ADDENDUM NO. 2

To the Contract Documents for
Sitework at the Commerce Street
Electric Substation

The Borough of Chambersburg, PA

2800-3751BL
2800-3752BL

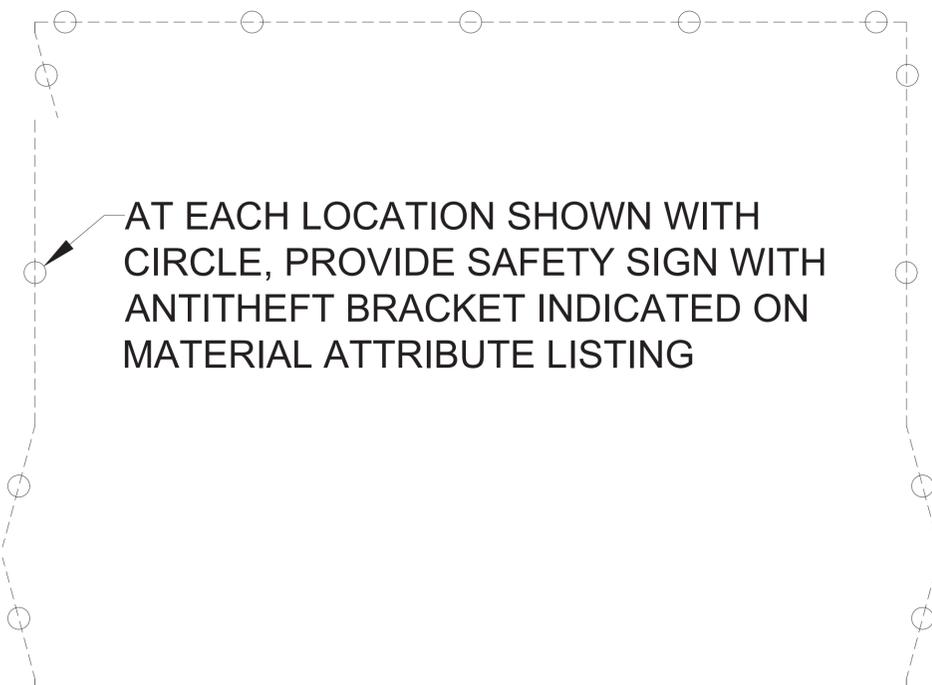
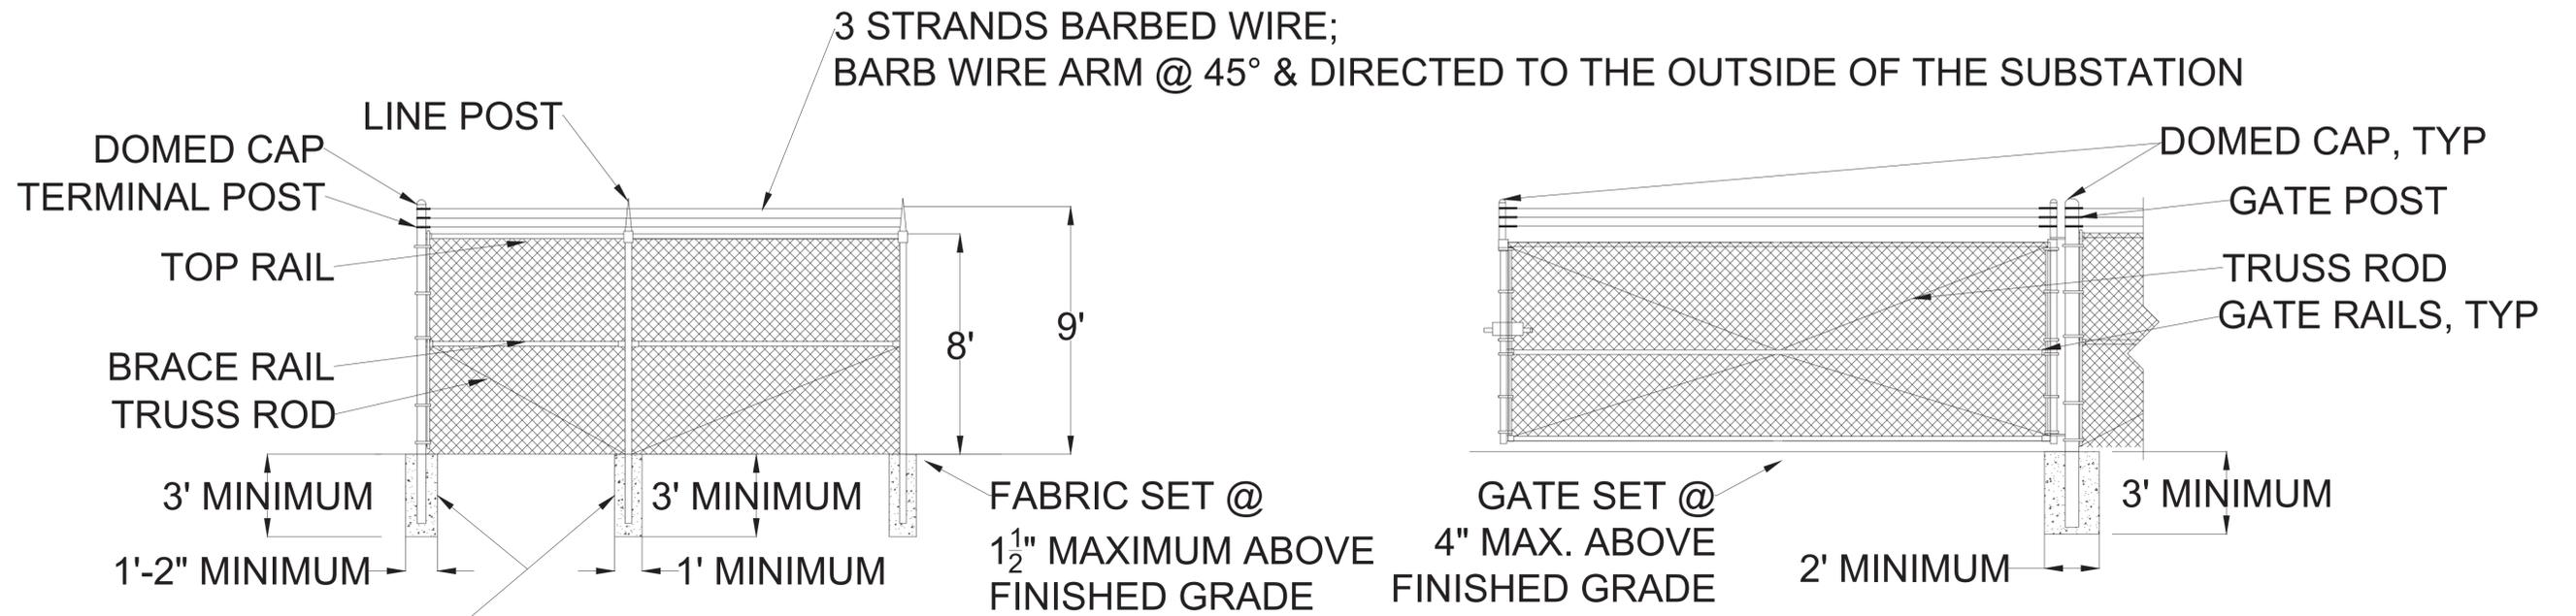
Attached Revised Preston Waller & Associates, Inc. Fence drawings. The Scale Information was removed from drawing 2800-3751BL.
